JLG 13070B-5A Construct New IT Center

St Cloud VAHCS Proj. No. 656-14-246

RE: Amendment No. 4

## Amendment No.4 (05.12.2016)

2 PLUMBING FIRST FLOOR PLAN

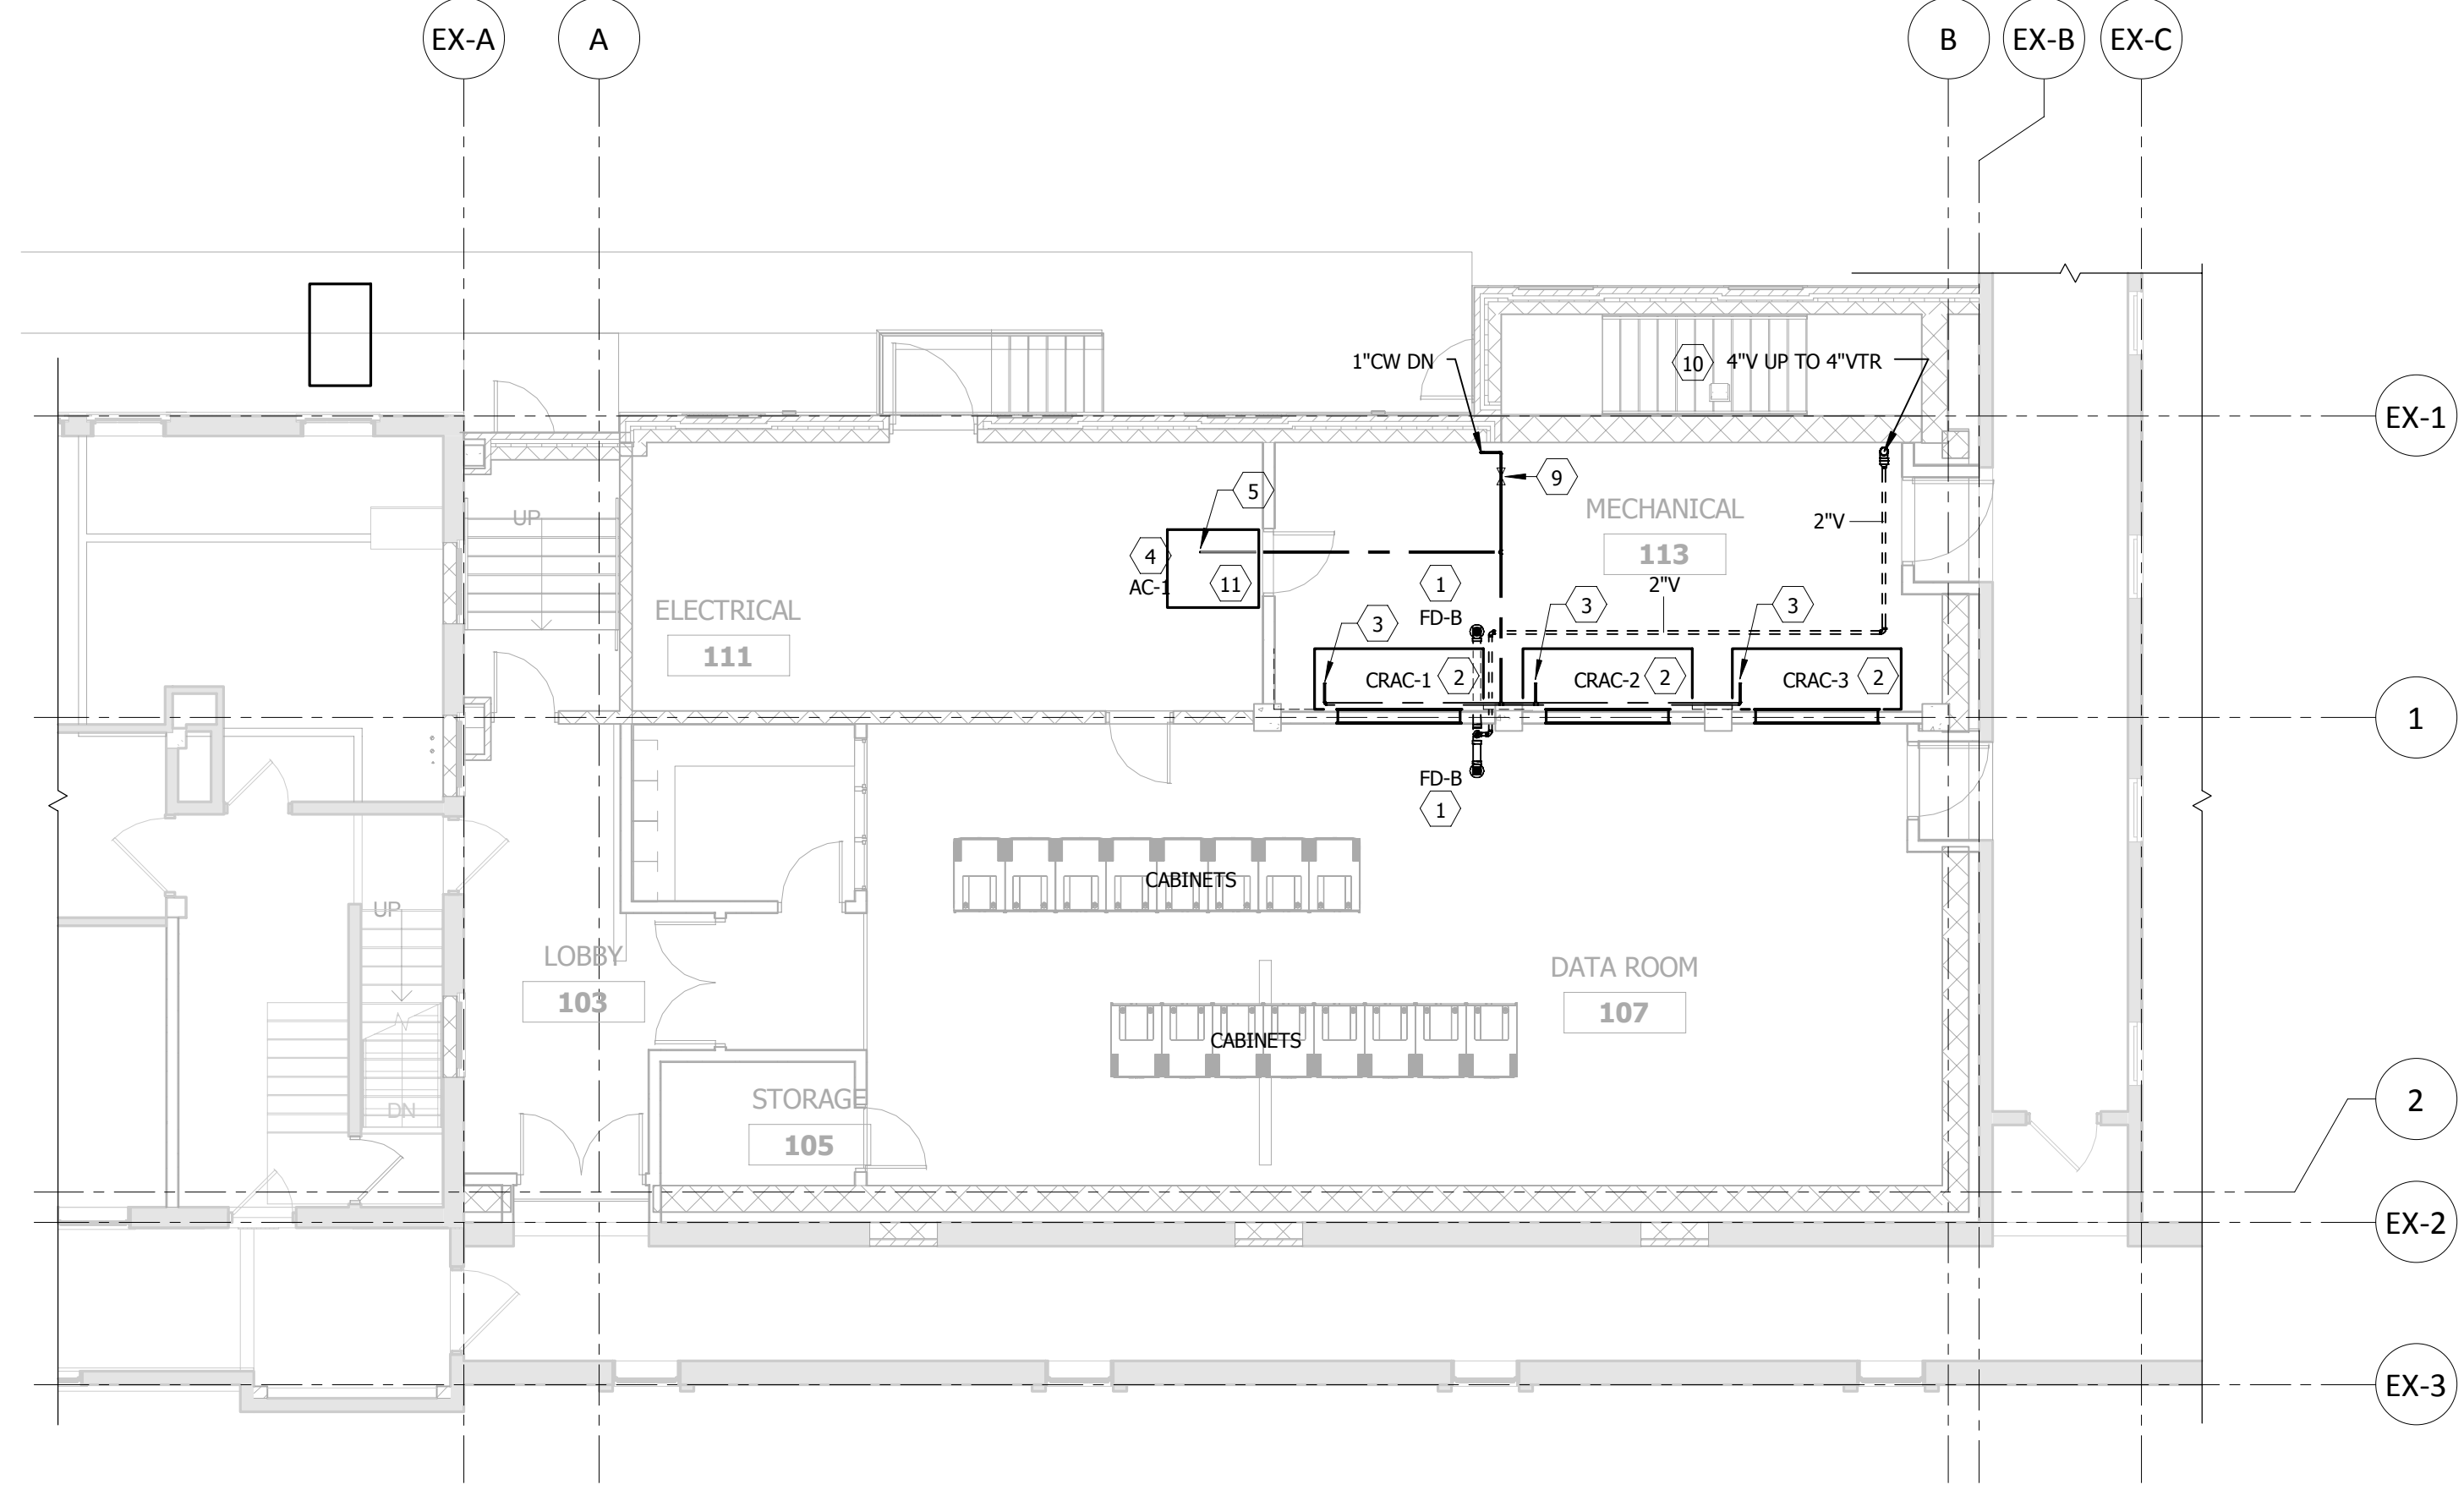
11. Drawing M201, M202, M402, M701, and M801: See attached revisions.
